Haweswater Aqueduct Resilience Programme - Proposed Bowland Section

Supplementary Environmental Information Report

Project No: B27070CT
Document Title: Proposed Bowland Section
Supplementary Environmental Information Report
Document Ref.: LCC_RVBC-BO_SEI
Revision: 0
Date: February 2022
Client Name: United Utilities Water Ltd

B3

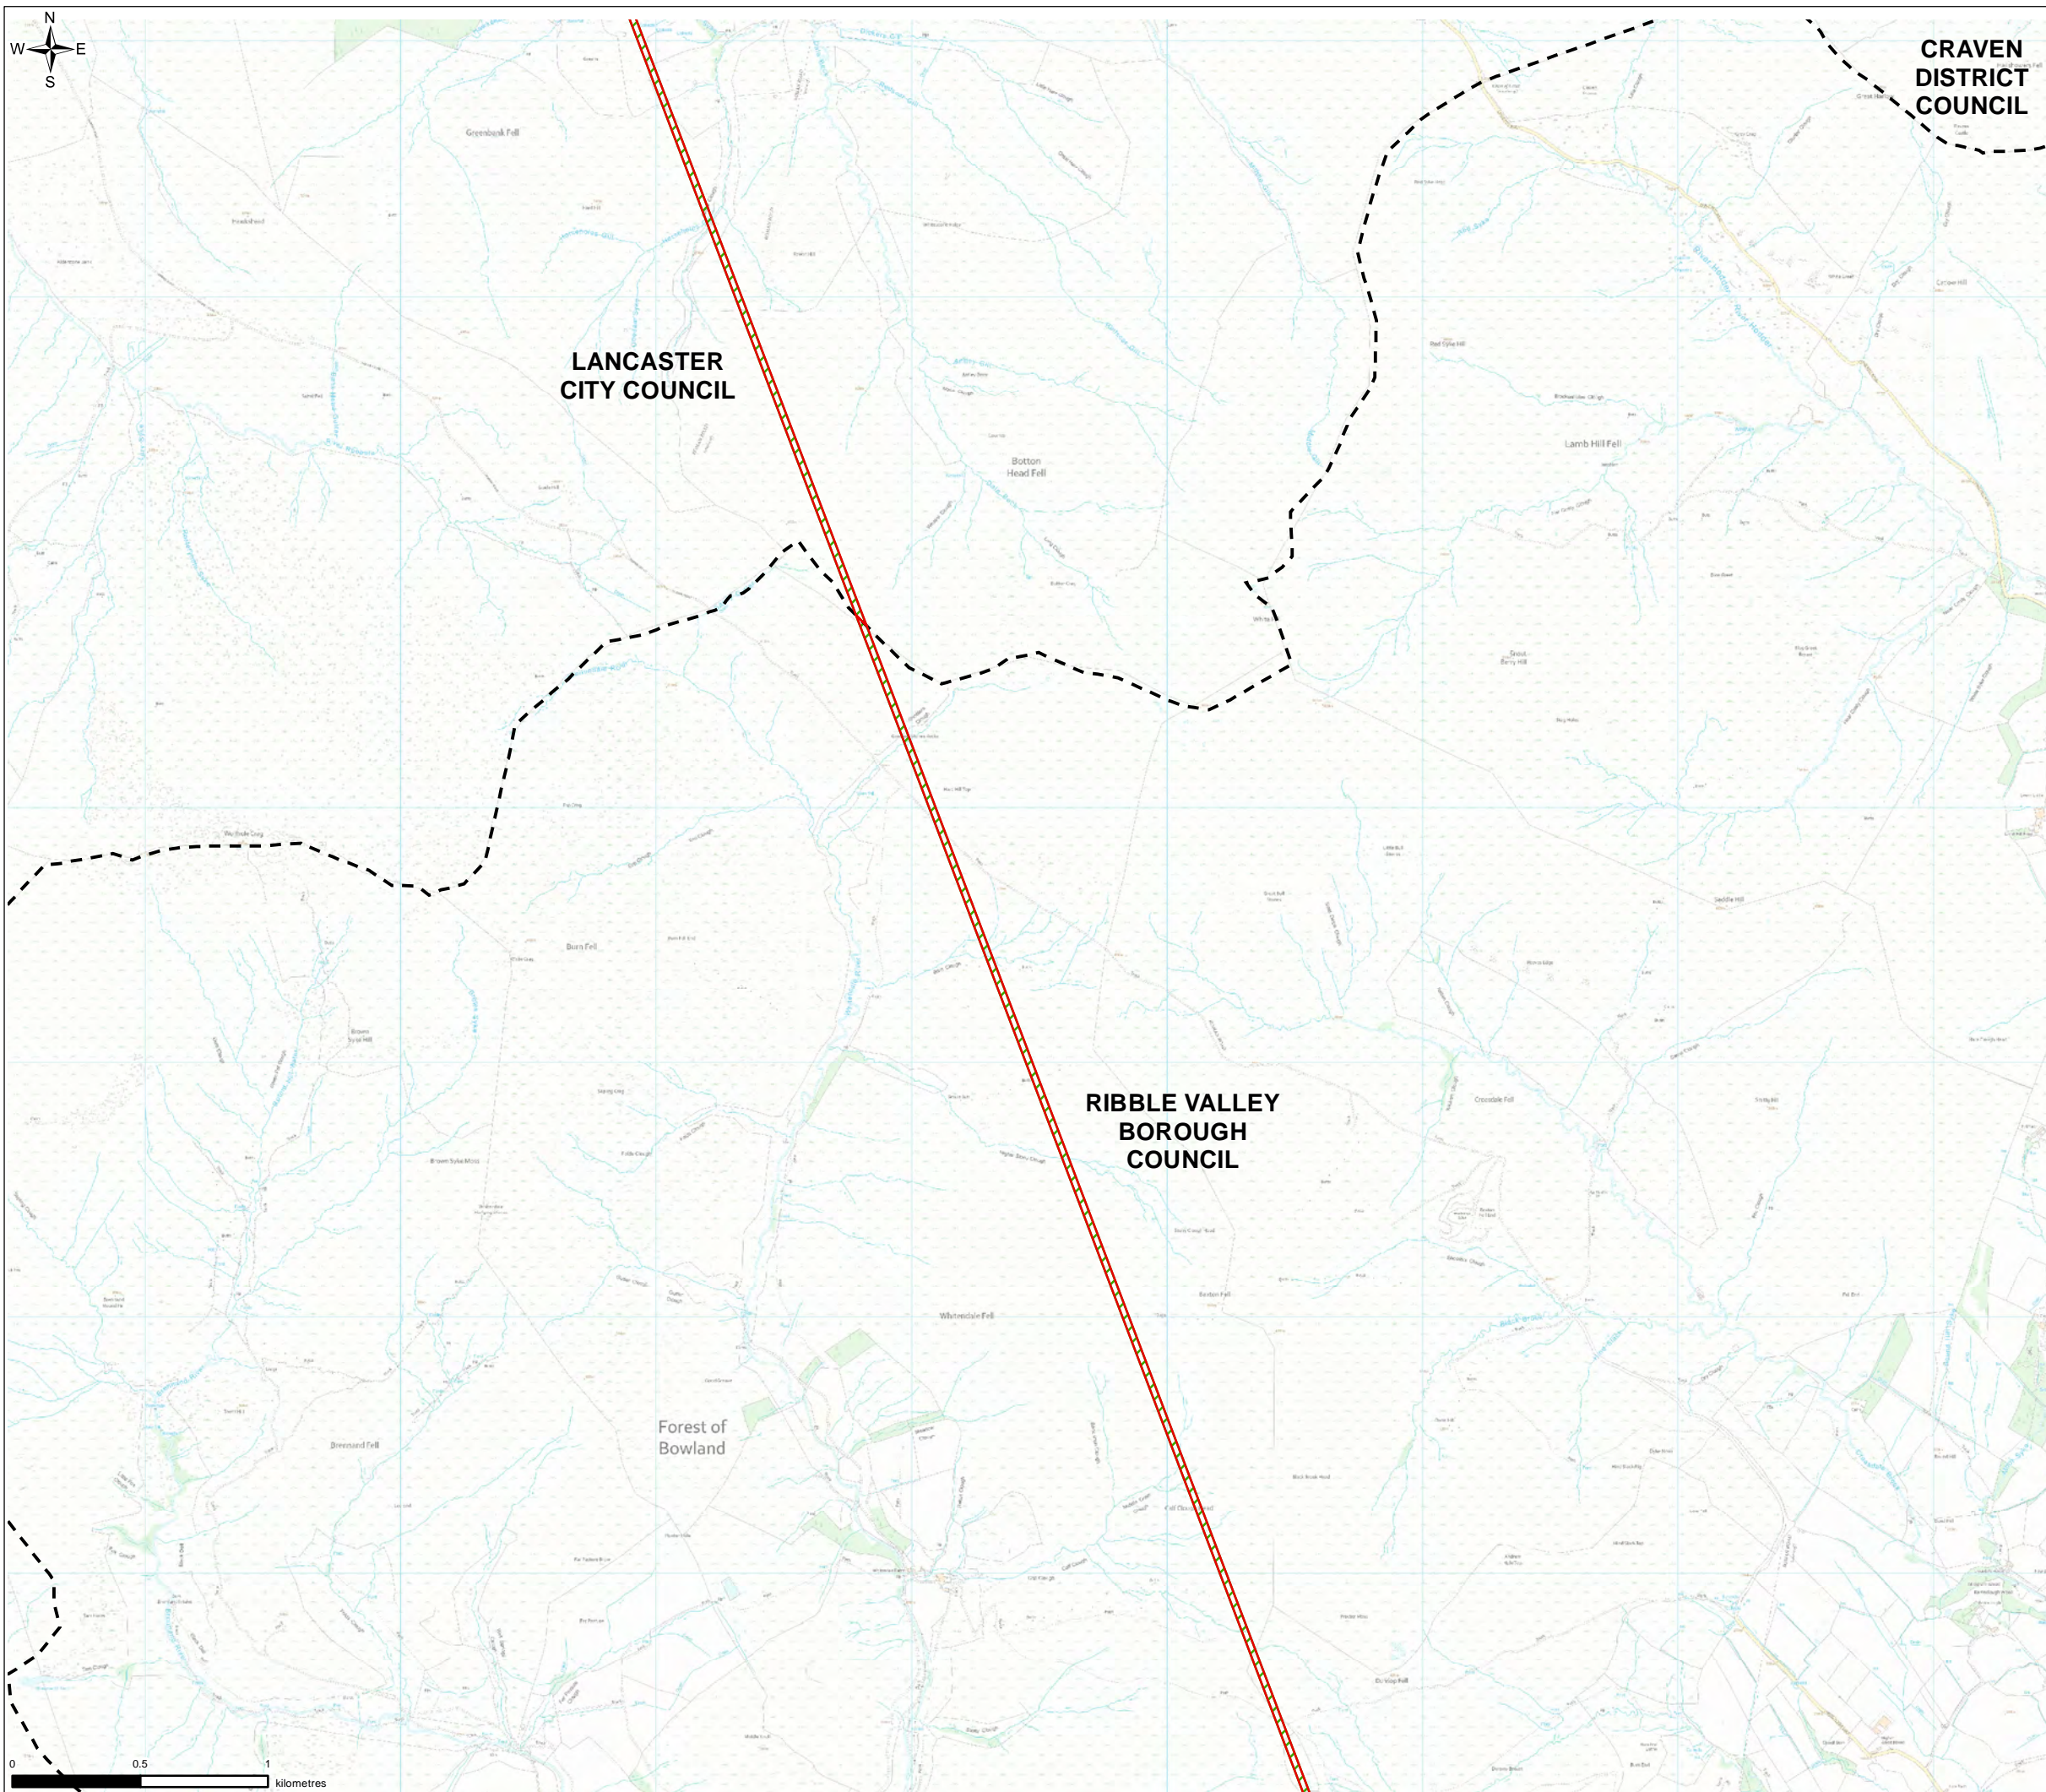
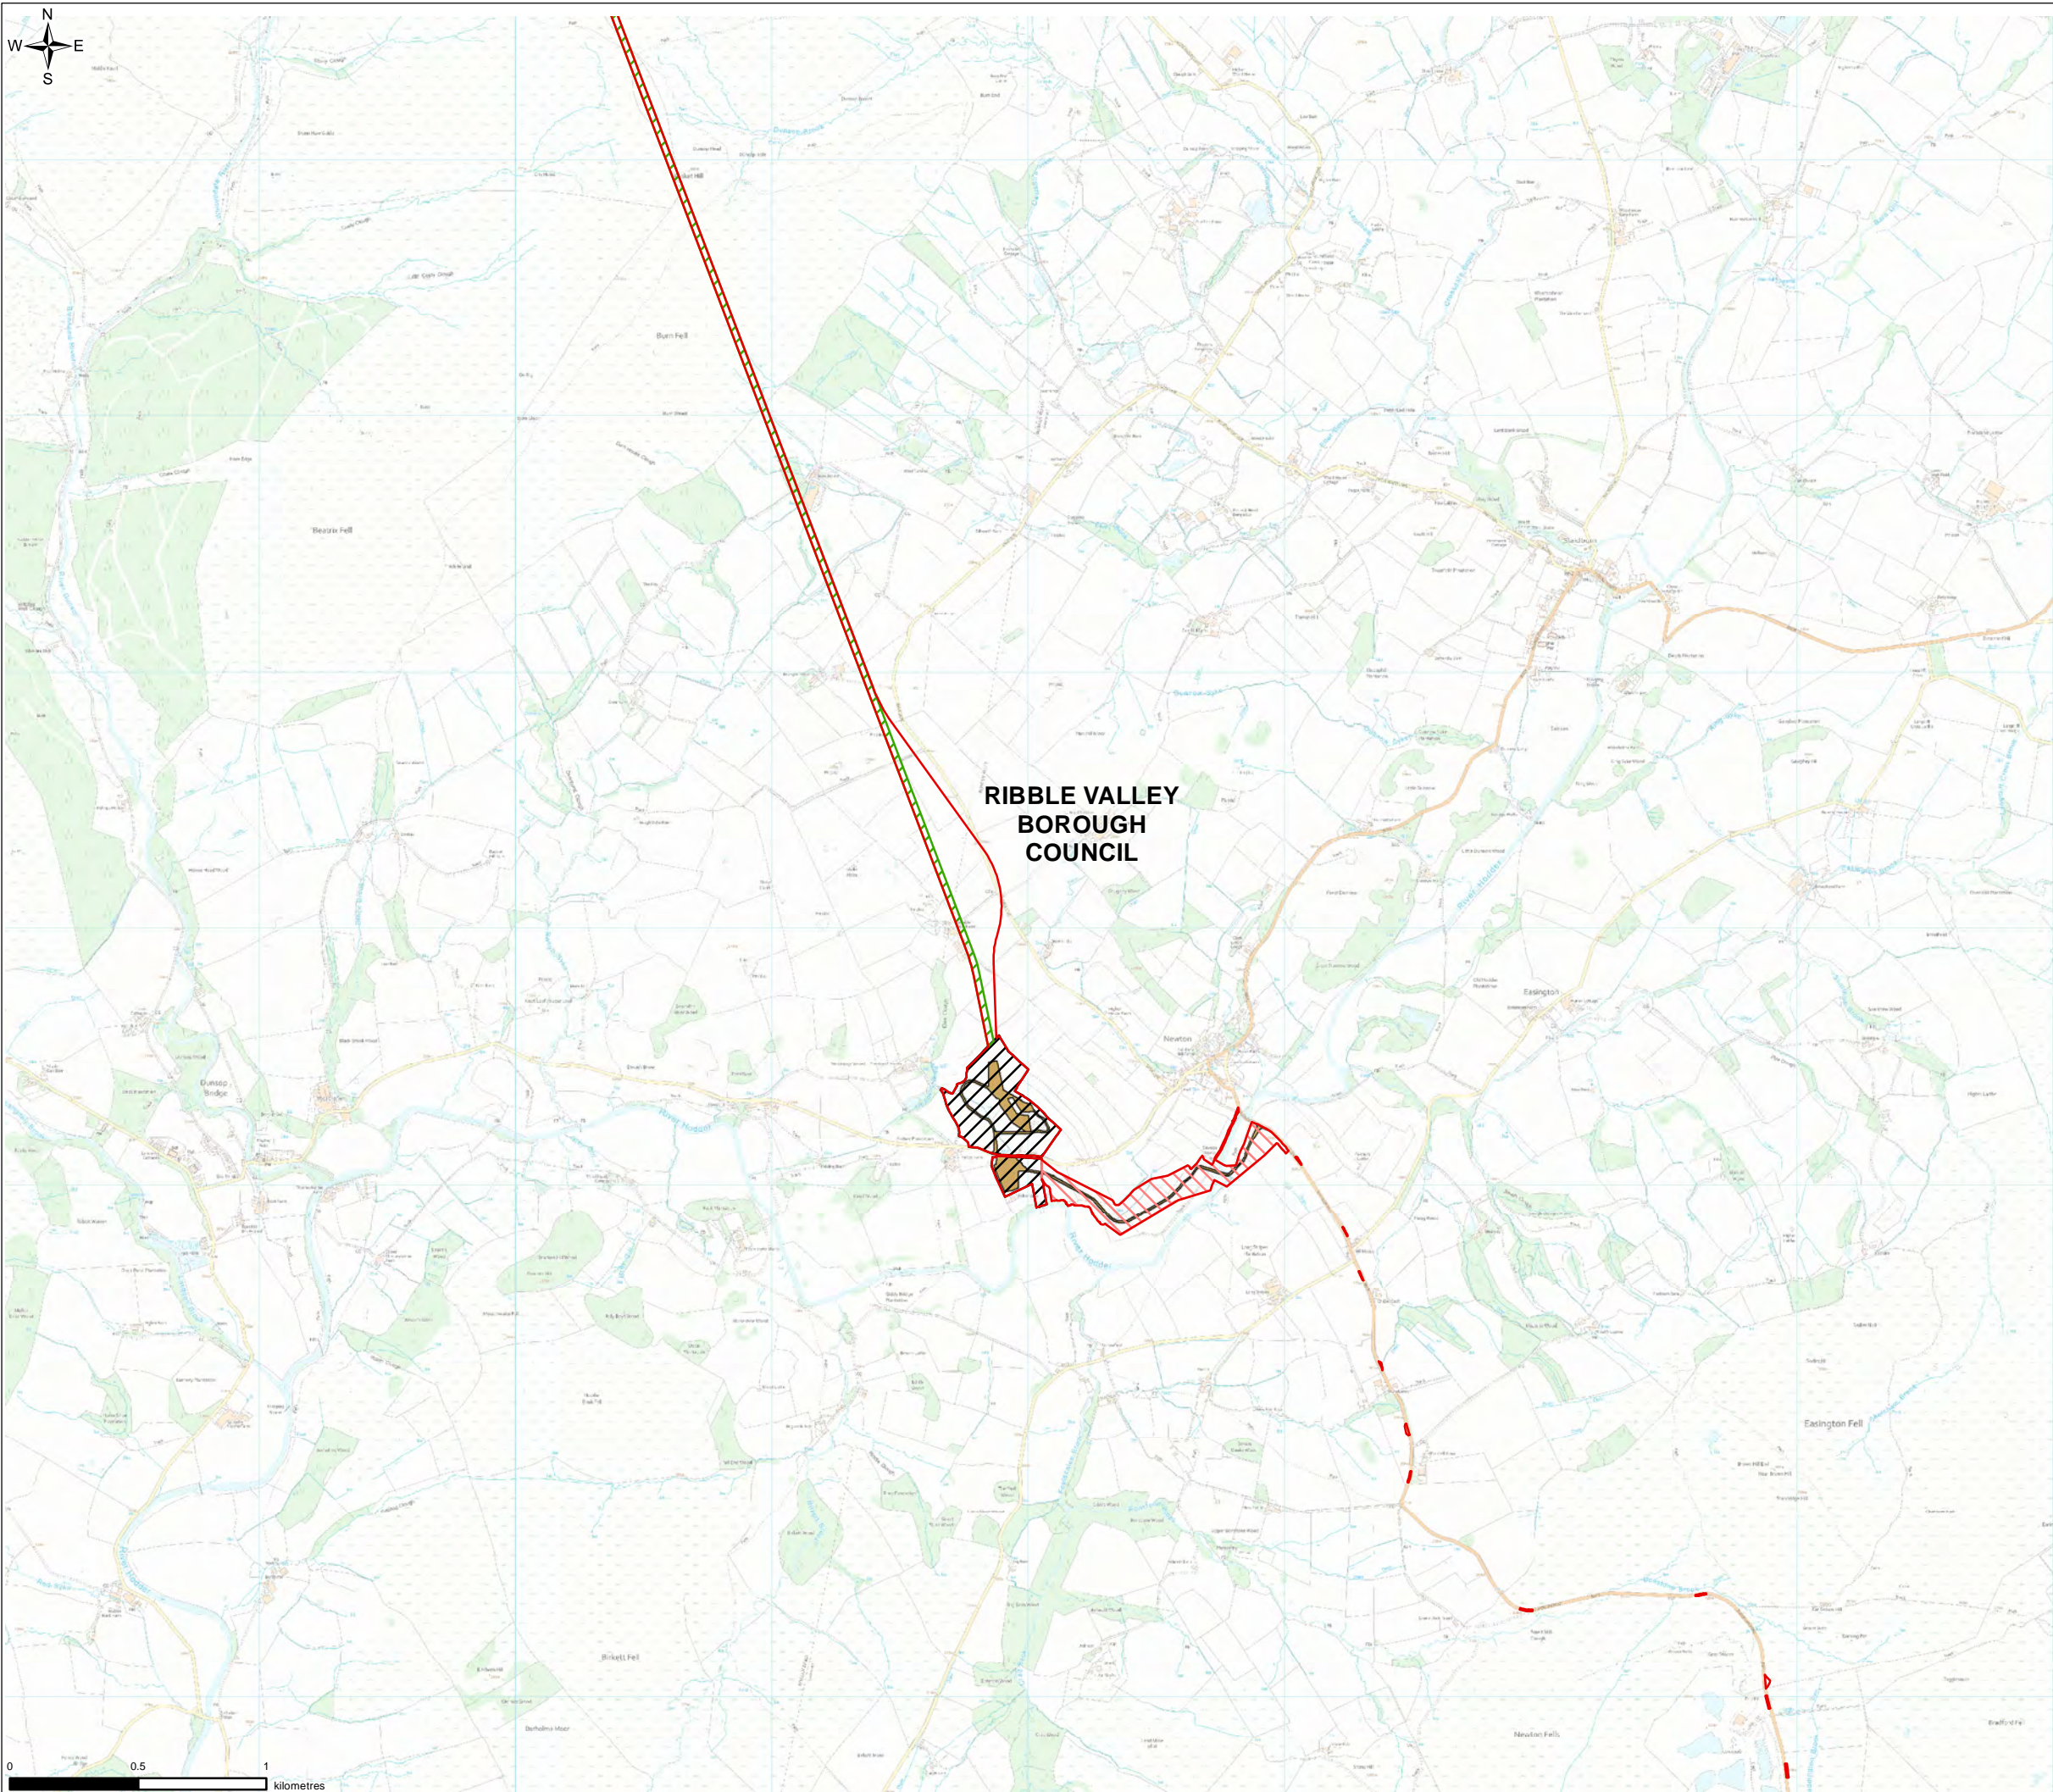
- 28) Figures 3.1a and 3.1b present the updated planning application boundaries for the Proposed Bowland Section; more detailed and larger scale drawings are provided in the February 2022 Revised Planning Application documents. Figure 3.1a focuses on the main construction compounds and the route of the tunnel below ground level. Figure 3.1b shows all the elements of the Proposed Bowland Section at a smaller scale, including satellite compounds and off-site highways works.
- 29) A screening exercise has been undertaken to identify where likely significant effects may arise in relation to the changes and new proposals. This has involved testing the proposed changes against each EIA topic to establish whether any likely significant effect may arise. The outcomes are summarised in Table 6.
